Access Compliance Report

Public Rights-of-Way

(Curb Ramps)

Intersection ID: 10035679	Main Street: RED_RUST_LN	Cross Street: N/A	Location: W
ADA ID: 504DCBCBDBF8	Ramp Type: Perp	Initial Pass/Fail: Fail	Overall Compliance: No
		Severity Score: 12.5

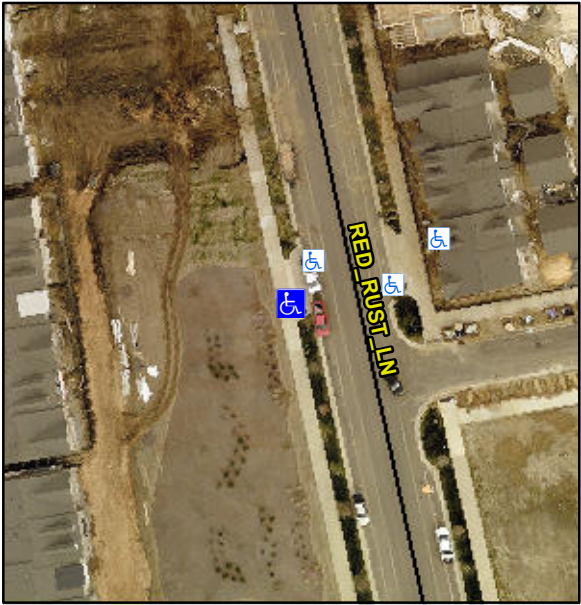
Codes/Mitigation Info/Possible Solution			Field Measurements/Component Compliance		
	Possible Solutions:		Compliance	Description	Data
	Remove & Replace Entire Ramp.		N/A	Ramp Length (in)	66.0
			Yes	Ramp Width (in)	61.5
			N/A	Flare Type LT	N/A
			N/A	Flare Slope LT (%)	N/A
			N/A	Flare Traversable LT?	N/A
			N/A	Landing Length (in)	N/A
			N/A	Landing Width (in)	N/A
			N/A	Landing Slope (%)	N/A
			N/A	Landing X Slope (%)	N/A
<p>Surveyor Notes:</p> <p>N/A</p> <p>PROW/ADA:</p> <p>R304.2.2</p>			N/A	Flare Type RT	N/A
			N/A	Flare Slope RT (%)	N/A
			N/A	Flare Traversable RT?	N/A
			N/A	DWS Provided?	N/A
			N/A	DWS Contrast?	N/A
			N/A	DWS Length (in)	N/A
			N/A	DWS Full Width?	N/A
			N/A	DWS Offset (in)	N/A
			N/A	Gutter Ponding?	N/A
			N/A	Gutter Lip Ht (in)	N/A
			N/A	Painted X Walk1?	No
				X Walk 1 Direction	To NE
			N/A	X Walk 1 Width (in)	N/A
				X Walk 1 Slope (%)	4.7
				X Walk 1 X Slope (%)	1.8
			N/A	Ramp inside XWalk1?	N/A

Road Slope (%)	N/A
				Road X Slope (%)	N/A
			N/A	Any Obstructions?	N/A
				Obstruction Type	
Total Cost:			\$	1850.00	
					N/A
				Yes	Surface Condition? (G/P)
					Good
